Work Order ID 70566

Item Name: 350 Basket Base

DART SERVICE INSTRUCTION

TO AMEND DRAWING D350-607 REV. F OR SUBSEQUENT APPROVED REVISION

FIGURE 1

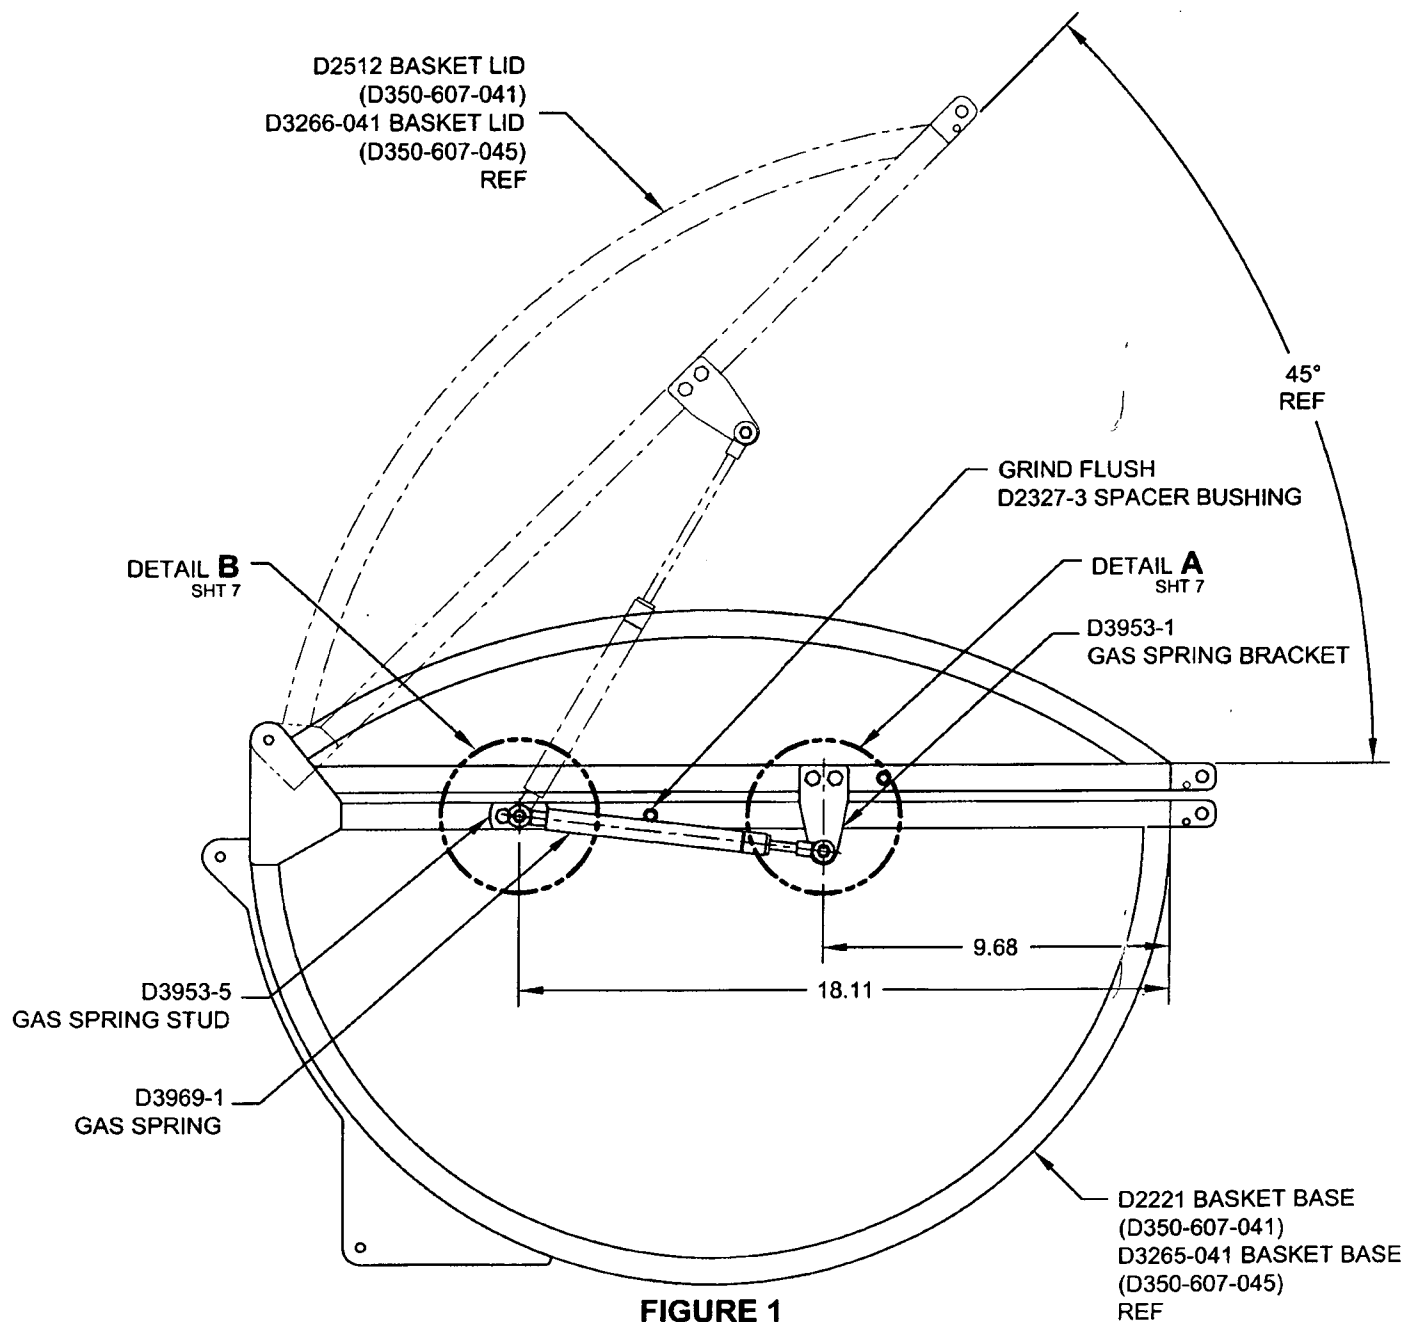
- 1) REMOVE THE D2332-041 PROP ARM.
 - 2) GRIND FLUSH THE D2327-3 SPACER BUSHING ON BOTH ENDS OF THE BASKET AS SHOWN IN FIGURE 1 (IT IS PERMISSIBLE TO GRIND ALL 4 SPACERS FLUSH). TOUCH UP PAINT PER ICA-D350-607 REV. 0 SECTION 5.1 ITEM 4.

- 3) LOCATE THE D3953-1 GAS SPRING BRACKET AS SHOWN IN FIGURE 1. TRIM STEEL MESH LOCALLY AS REQUIRED. TOUCH UP PAINT PER ICA-D350-607 REV. 0 SECTION 5.1 ITEM 4. TRANSFER MARK AND DRILL 2X Ø0.194 HOLES THRU THE BASKET LID SQUARE TUBE STRUCTURE AS SHOWN IN DETAIL A. INSTALL THE D3953-1 GAS SPRING BRACKET & D3953-13 GAS SPRING SPACER USING 2X AN3C16A BOLT, 2X NAS1149C0332R WASHER & 2X MS21043-3 NUT AS SHOWN IN VIEW E-E.

- 4) LOCATE THE D3953-5 GAS SPRING STUD AS SHOWN IN FIGURE 1. TRIM STEEL MESH LOCALLY AS REQUIRED. TOUCH UP PAINT PER ICA-D350-607 REV. 0 SECTION 5.1 ITEM 4. TRANSFER MARK AND DRILL 2X Ø0.194 HOLES THRU THE BASKET BASE SQUARE TUBE STRUCTURE AS SHOWN IN DETAIL E. FASTEN D3953-5 IAW VIEW F-F USING 2X AN3C11A BOLT, 2X NAS1149C0332R WASHER & 2X MS21043-3 NUT.

FIGURE 2
D350-607-143 AUTOMATIC LID OPENER INSTALLATION
 (1 END ONLY)

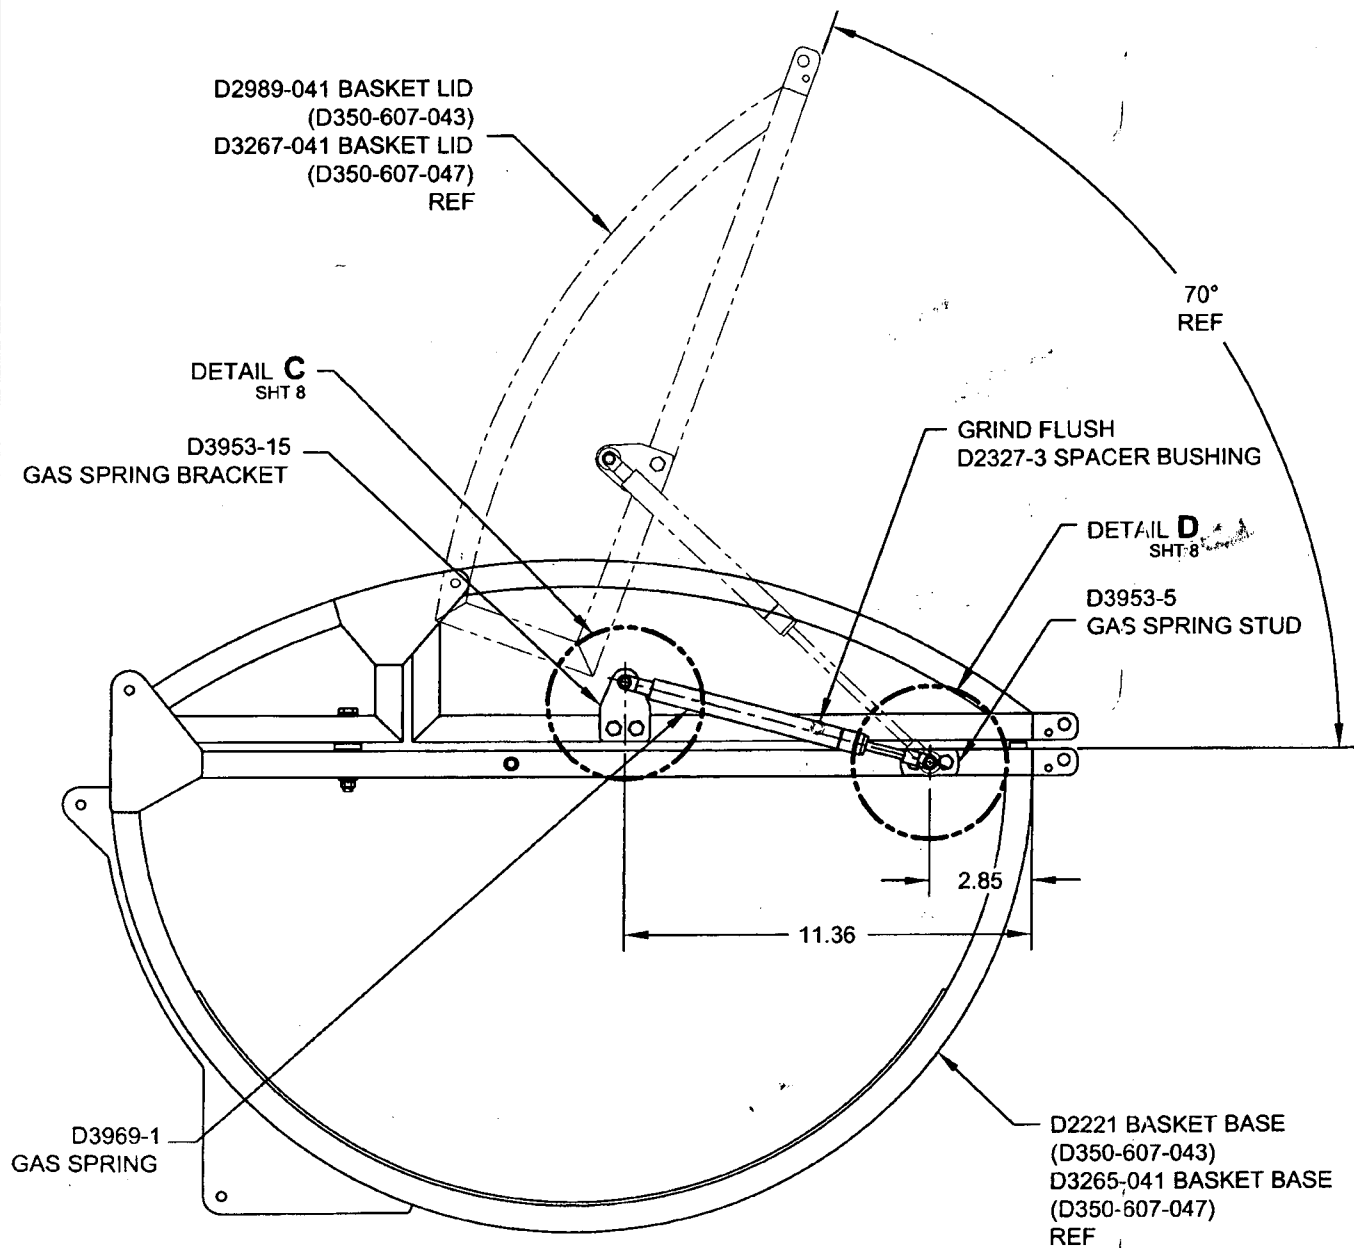
- 1) REMOVE THE D2332-041 PROP ARM.
- 2) GRIND FLUSH THE D2327-3 SPACER BUSHING ON THE END OF THE BASKET WHERE THE LID OPENER IS BE INSTALLED AS SHOWN IN FIGURE 2 (IT IS PERMISSIBLE TO GRIND ALL 4 SPACERS FLUSH). TOUCH UP PAINT PER ICA-D350-607 REV. 0 SECTION 5.1 ITEM 4.

- 3) LOCATE THE D3953-15 GAS SPRING BRACKET AS SHOWN IN FIGURE 2. TRIM STEEL MESH LOCALLY AS REQUIRED. TOUCH UP PAINT PER ICA-D350-607 REV. 0 SECTION 5.1 ITEM 4. TRANSFER MARK AND DRILL 2X Ø0.194 HOLES THRU THE BASKET LID SQUARE TUBE STRUCTURE AS SHOWN IN DETAIL C. INSTALL THE D3953-15 GAS SPRING BRACKET & D3953-17 GAS SPRING SPACER USING 2X AN3C15A BOLT, 2X NAS1149C0332R WASHER & 2X MS21043-3 NUT AS SHOWN IN VIEW G-G.

- 4) LOCATE THE D3953-5 GAS SPRING STUD AS SHOWN IN FIGURE 2. TRIM STEEL MESH LOCALLY AS REQUIRED. TOUCH UP PAINT PER ICA-D350-607 REV. 0 SECTION 5.1 ITEM 4. TRANSFER MARK AND DRILL 2X Ø0.194 HOLES THRU THE BASKET BASE SQUARE TUBE STRUCTURE AS SHOWN IN DETAIL D. INSTALL 2X AN3C11A BOLT, 2X NAS1149C0332R WASHER & 2X MS21043-3 NUT AS SHOWN IN VIEW H-H. INSTALL THE ROD END OF THE D3969-1 GAS SPRING ONTO THE D3953-3 GAS SPRING STUD USING 1X D3953-9 GAS SPRING WASHER, 1X NAS1149C0432R WASHER, 1X AN310-4 CASTELATTED NUT & 1X MS24665-212 COTTER PIN AS SHOWN IN VIEW H-H. INSTALL COTTER PIN PER MS33540 OR AC43.13 CHAPTER 7-127.

VIEW F-F

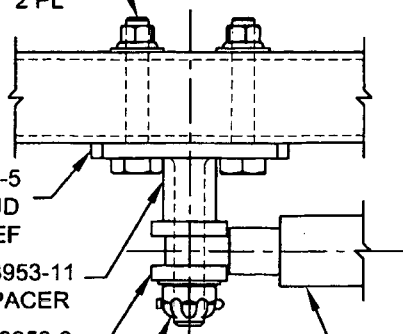
- 5) INSTALL 1X D3953-11 GAS SPRING SPACER ONTO THE D3953-5 STUD AS SHOWN IN VIEW F-F. INSTALL THE LARGE END OF THE D3969-1 GAS SPRING SPRING ONTO THE D3953-5 GAS SPRING STUD AND FASTEN IN PLACE USING 1X D3953-9 GAS SPRING WASHER, 1X NAS1149C0432R WASHER, 1X AN310-4 CASTELATTED NUT & 1X MS24665-212 COTTER PIN AS SHOWN IN VIEW F-F. INSTALL COTTER PIN PER MS33540 OR AC43.13 CHAPTER 7-127.

VIEW E-E

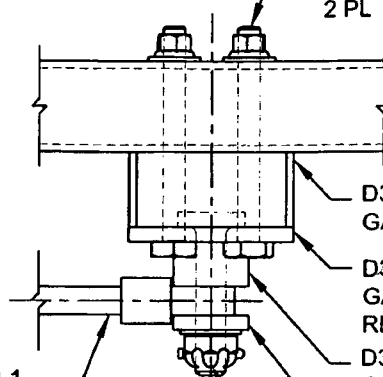
- 6) INSERT THE D3953-3 GAS SPRING STUD INTO THE D3953-1 GAS SPRING BRACKET & INSERT THE D3953-7 GAS SPRING SPACER ONTO THE D3953-3 GAS SPRING AS SHOWN IN VIEW E-E. RAISE THE BASKET LID AND INSTALL THE ROD END OF THE D3969-1 GAS SPRING ONTO THE D3953-3 GAS SPRING STUD USING 1X D3953-9 GAS SPRING WASHER, 1X NAS1149C0432R WASHER, 1X AN310-4 CASTELATTED NUT & 1X MS24665-212 COTTER PIN AS SHOWN IN VIEW E-E. INSTALL COTTER PIN PER MS33540 OR AC43.13 CHAPTER 7-127.
NOTE: THE D3953-3 GAS SPRING STUD CAN BE HELD IN PLACE WITH A $\frac{9}{16}$ OPEN END SPANNER / WRENCH.

DETAIL B

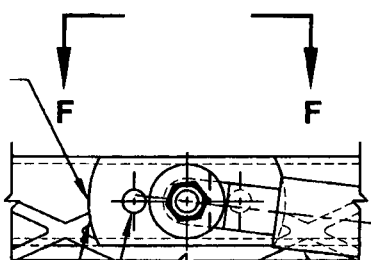
- 4) LOCATE THE D3953-5 GAS SPRING STUD AS SHOWN IN FIGURE 1. TRIM STEEL MESH LOCALLY AS REQUIRED. TOUCH UP PAINT PER ICA-D350-607 REV. 0 SECTION 5.1 ITEM 4. TRANSFER MARK AND DRILL 2X Ø0.194 HOLES THRU THE BASKET BASE SQUARE TUBE STRUCTURE AS SHOWN IN DETAIL B. FASTEN D3953-5 IAW VIEW F-F USING 2X AN3C11A BOLT, 2X NAS1149C0332R WASHER & 2X MS21043-3 NUT.

DETAIL A

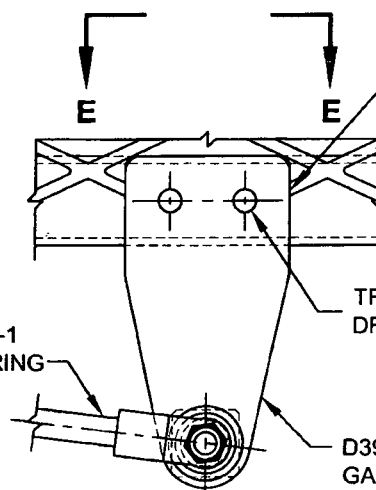
- 3) LOCATE THE D3953-1 GAS SPRING BRACKET AS SHOWN IN FIGURE 1. TRIM STEEL MESH LOCALLY AS REQUIRED. TOUCH UP PAINT PER ICA-D350-607 REV. 0 SECTION 5.1 ITEM 4. TRANSFER MARK AND DRILL 2X Ø0.194 HOLES THRU THE BASKET LID SQUARE TUBE STRUCTURE AS SHOWN IN DETAIL A. INSTALL THE D3953-1 GAS SPRING BRACKET & D3953-13 GAS SPRING SPACER USING 2X AN3C16A BOLT, 2X NAS1149C0332R WASHER & 2X MS21043-3 NUT AS SHOWN IN VIEW E-E.
